ADDENDUM #2 TO THE ENVIRONMENTAL IMPACT REPORT

PITTSBURG MARINE TERMINAL, UP-95-05

CITY OF PITTSBURG, CALIFORNIA

September 28, 1995

Figure 1
PROPOSED REVISED SITE PLAN
Pittsburg Marine Terminal (UP-95-05) EIR Addendum #2
City of Pittsburg, California

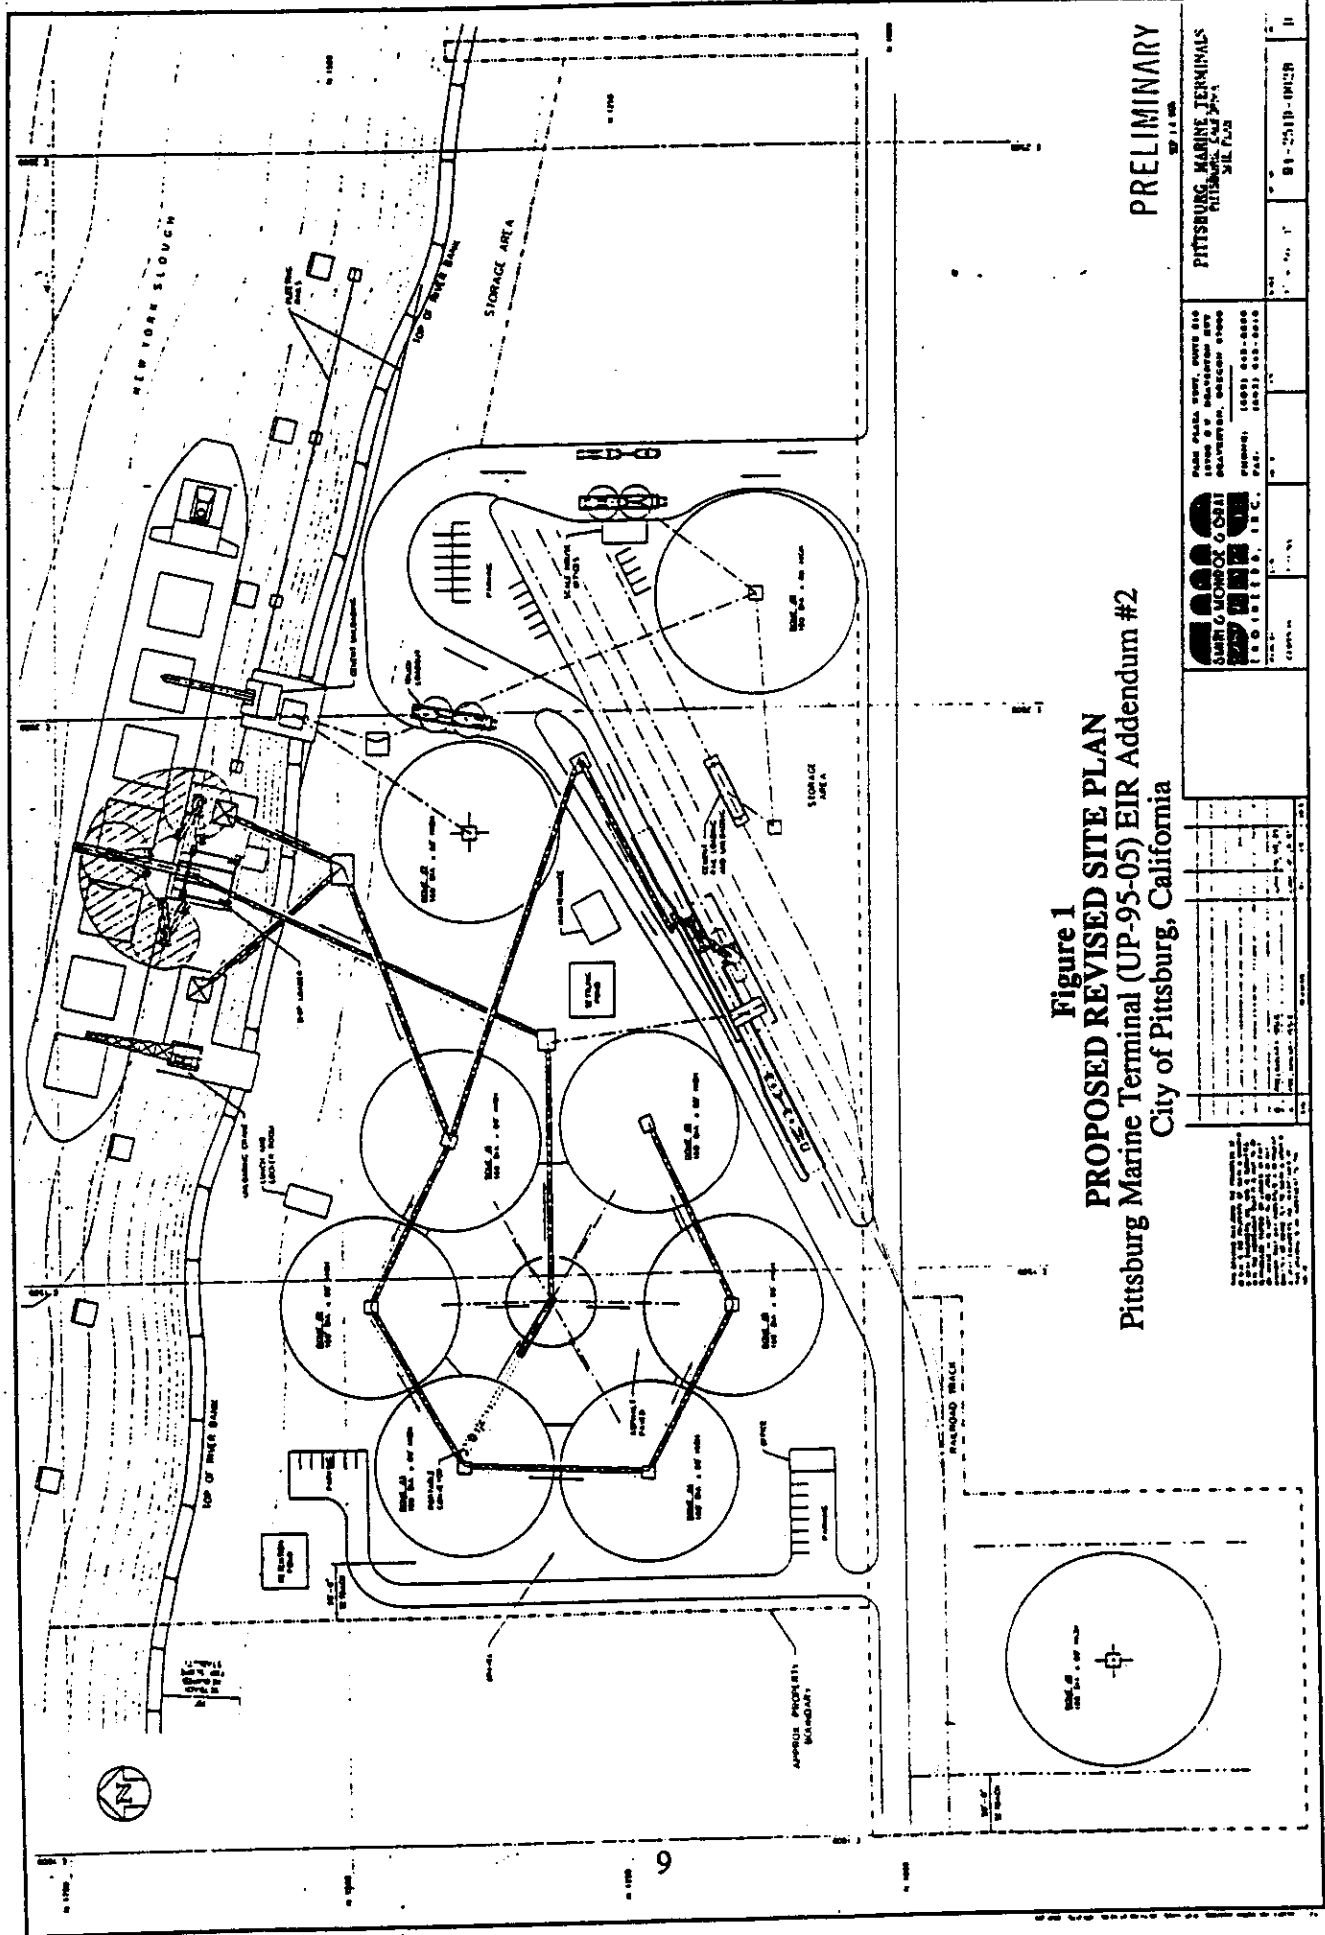
The revised Site Plan of the Project (Revision B dated 9/8/95, by Smith & Monroe & Gray Engineers, Inc.) is shown in **Figure 1**. A total of nine domes are indicated for construction on the site, six of which are placed in a circular arrangement at the west side of the site. Each of these domes (Domes #1 - #6) is indicated to be 160 feet in diameter and 80 feet in height, and they are connected at their upper central points by a system of enclosed conveyors to each other, to a ship loader at the dockside, and to the truck and rail loading/unloading facility located at the center of the south side of the site. In the center of this circle of domes is a portable conveyor to access the interior of each dome at lower levels than the top of each dome. Towards the east side of the site, west of the GWF site, are Dome #7, which is indicated as having the same dimensions as Domes #1 through #6, and Dome #8, which is slightly larger (180 feet in diameter and 80 feet in height). These two domes are also connected to each other at their upper central points by a similar system of enclosed conveyors, and to a cement loader at the dockside and the truck and rail loading/unloading facility mentioned above. Dome #9 is located on the separate parcel of land at the southeastern-most corner of the site, on the south side of East Third Street, and is indicated to be 190 feet in diameter and 80 feet in height. It is not shown as connected to the facilities on the main portion of the site by any conveyor system.

Figure 2
PROPOSED REVISED SITE PROFILES (ELEVATIONS)
 Pittsburgh Marine Terminal (UP-95-05) EIR Addendum #2
 City of Pittsburgh, California

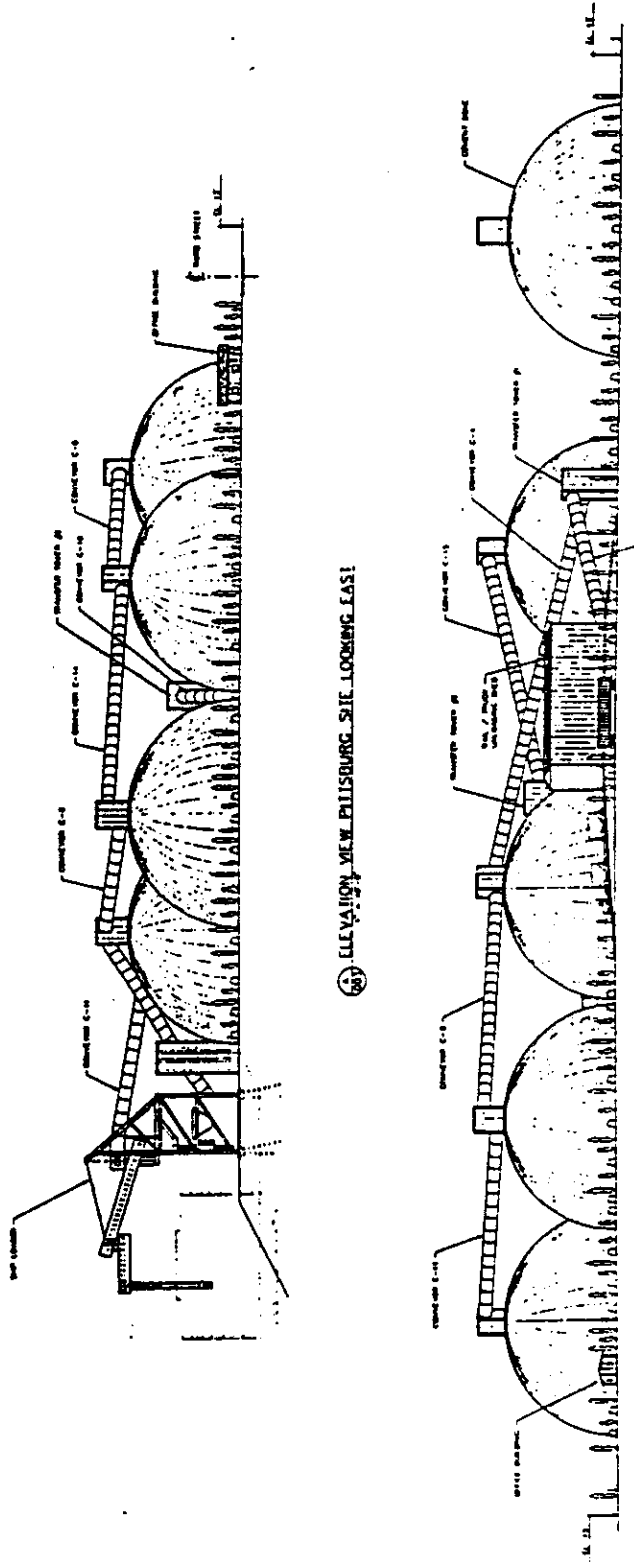
Figure 2 provides a pictorial representation of the proposed development of the Project site in terms of the elevations of the domes and other facilities as seen from the west side of the site looking east, and from the south side of the site looking north. The general character of the enclosed conveyors linking the tops of the domes and the height and appearance of the ship loader can be understood from these elevational profiles.

The applicants have indicated that the needed height of the loading/unloading equipment on the dock is a function of the height of the decks of the ships which must be served. The 80-foot height of the proposed domes is indicated to be necessary to enable the internal space to be effectively utilized, given the angle of repose characteristic of the materials to be handled. The enclosed conveyors require additional height above the top of the domes to be fully functional (see Figure 2 on page 10).

The domes and loading equipment as now proposed for the Project site would exceed in height the structures previously evaluated for their visual impact. However, the remote location of the site, situated at some distance from sensitive land uses, and surrounded by other industrial development having some higher structures than those now requested, has the effect of diminishing the significance of the five to fifteen foot increase in structure height now requested in excess of the 95 foot maximum height previously evaluated. The loading/unloading structures, which would be the highest structures on the site, are located along the northernmost strip of the site, alongside the shoreline. This location not only would be partly screened from view from the south and (to some extent) from the west by the storage domes, the height of the structures as perceived from off-site would tend to be diminished by the additional distance (about 600 feet from the southern property line), and by the open-work character of the loaders as illustrated in Figure 2.

40. *The maximum height for domes shall be 80 feet plus up to 20 feet that shall be allowed for equipment on top. The maximum height for loading and unloading structures and equipment on the dock shall be 110 feet. the maximum height for all other structures shall be 75 feet plus up to 20 feet that shall be allowed for equipment on top.*
